# Barangaroo

## **BARANGAROO HEADLAND PARK AND NORTHERN COVE MAIN WORKS – PROPOSED MODIFICATION TO APPROVAL MP10\_0048**

# Attachment A - Barangaroo Headland Park and Northern Cove Main Works, Modification Request 6

Figure 3 Current Proposed Approved Boundary (excerpt from Drawing CO-JPW-L-S3-0100, Rev 4, dated January 2015)

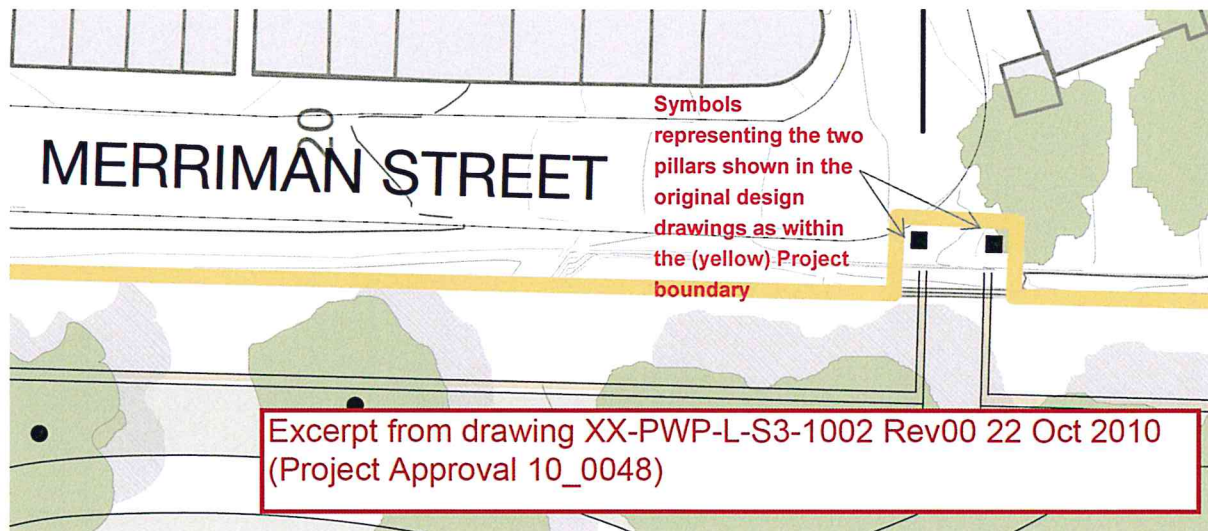
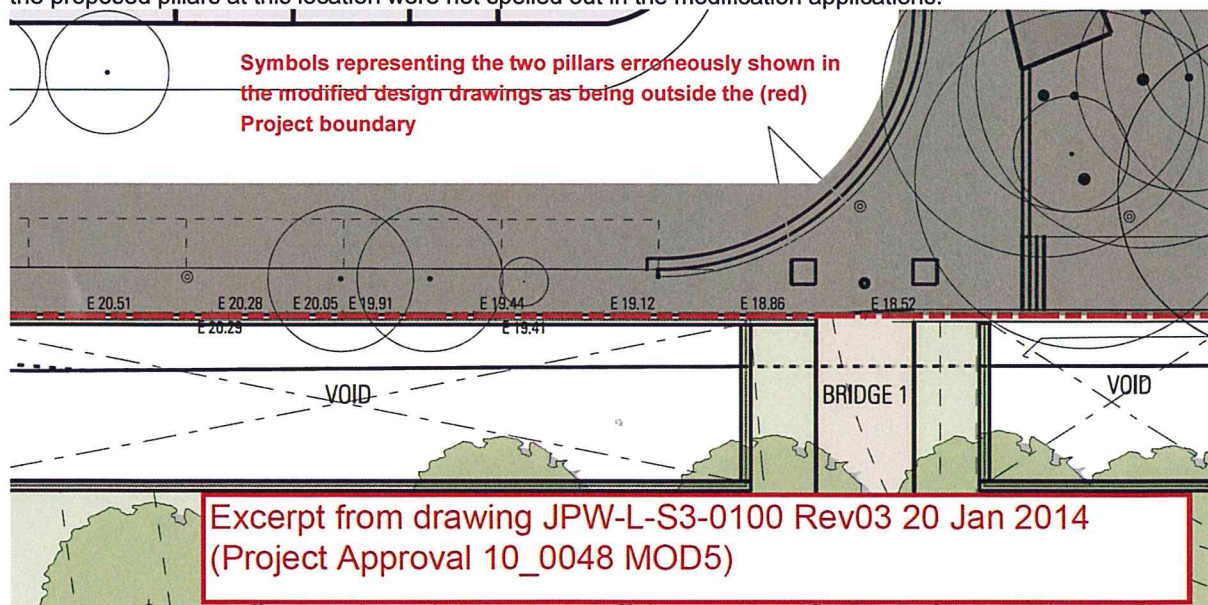
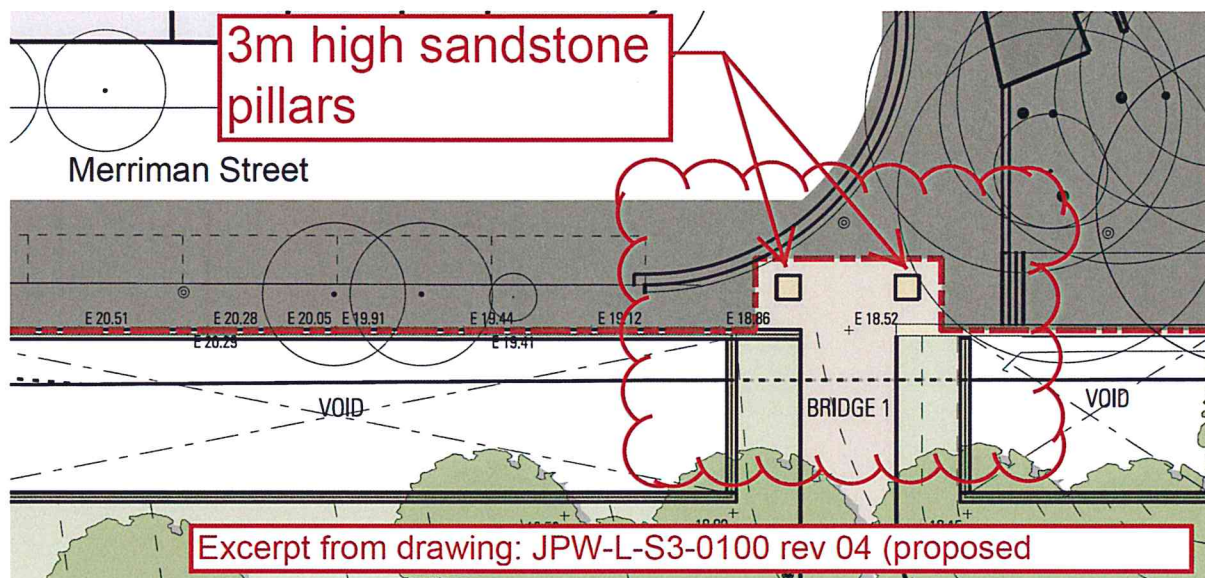
In subsequent modifications to MP 10\_0048 (MOD 5), the boundary of the Project was erroneously shown as excluding the pillars, although the symbols representing the pillars continued to be shown in the submitted design documentation (CO-JPW-L-S3-0100, Rev 3, dated 20 January 2014) (Refer Figure 2). The proposed positions of the pillars in the submitted documentation remained materially unchanged from that shown in the original MP10\_0048 approval (Refer Figure 2), however as before the documentation did not make clear what the two symbols were representing. Additional details regarding the proposed pillars at this location were not spelled out in the modification applications.

The current modification is sought to amend the Project boundary of MP 10\_0048 to again include the location of the pillars within the approved Project boundary for MP 10\_0048 as originally approved. The current design provided in Revision 4 of design drawings CO-JPW-L-S3-0100, shows the proposed location of the two pillars within the amended Project boundary (refer Figure 3).

This modification seeks to amend approval condition A2 of MP 10\_0048, to replace references to the design drawing CO-JPW-L-S3-0100, Rev 3, dated 20 January 2014 with the design drawing included in the current modification application (CO-JPW-L-S3-0100, Rev 4, dated January 2015) which shows the boundary of the Project (dashed red line) and identifies what the two symbols represent, being the two 3m high sandstone pillars.

The two pillars would comprise 3m high by 1 metre width sandstone pillars to act as markers to the entrance to the Headland Park from Merriman Street, and would be located within the footpath of Merriman Street (on the western side). Following discussions with City of Sydney Council regarding the design of the pillars the height of the pillars has been reduced from 5m to 3m.
